RE: Revised Planning Application # 2015/5847/P
Address: 66 Fitzjohns Avenue, London NW3 5LT

I wish to lodge our objection to the proposed revised application.

View of existing building from Fitzjohns Avenue

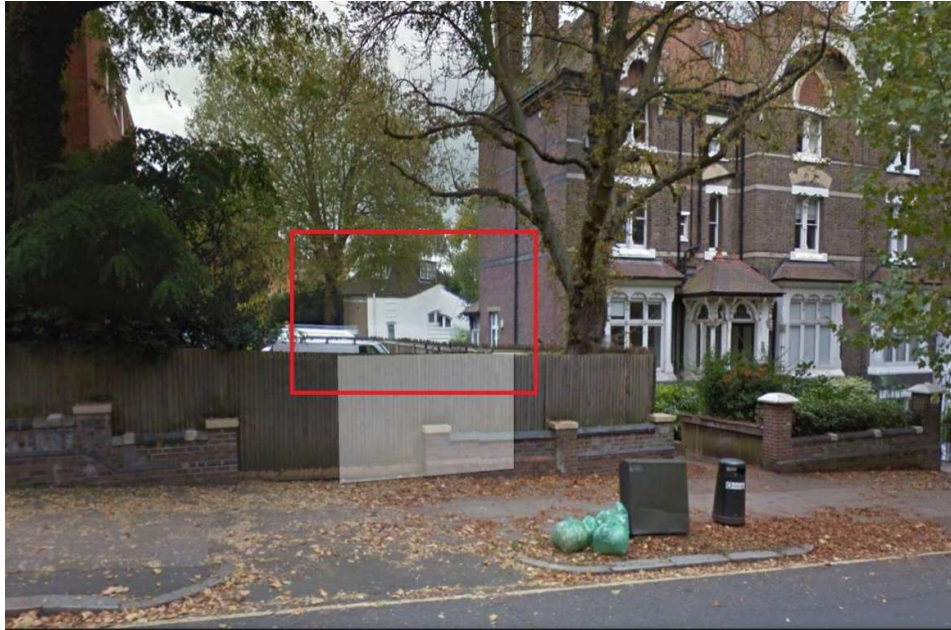
- 1) **The site is within the Hampstead Conservation Area and is a back land site** having been originally part of the garden belonging to 64 Fitzjohns Avenue. In our opinion **the proposal to raise the roof height by almost 1m remains unacceptable. The new construction should fit within the existing elevation profile.** The existing building roof height is generally 24.34m (to datum) with a parapet height of 24.58m. The proposed roof height (although not specifically put on the drawing (unfortunately as this is important information) would appear from scaling to be 25.35m (1m higher) with the parapet taking it to 25.45m. I can understand the argument being presented which is the parapet height is the same as the pointed front elevation façade elements. However, these should not be taken as the overall height of the existing building. Raising the whole front elevation to this level will undoubtedly have the effect of making the building appear blockier and bulky. The pitched front elevation parapets add to the charm of the existing building and also serves to soften the impact on the rear of 64 Fitzjohns which is in very close proximity. Changing the front elevation to a flat roof at the increased height across the whole frontage will also have a **detrimental effect on the Conservation Area.** As this building is clearly visible from the road.

Why did the Architect not provide a proposed elevation with the existing building dotted and overlaid which is usual practice and would allow the easy evaluation of the proposal?
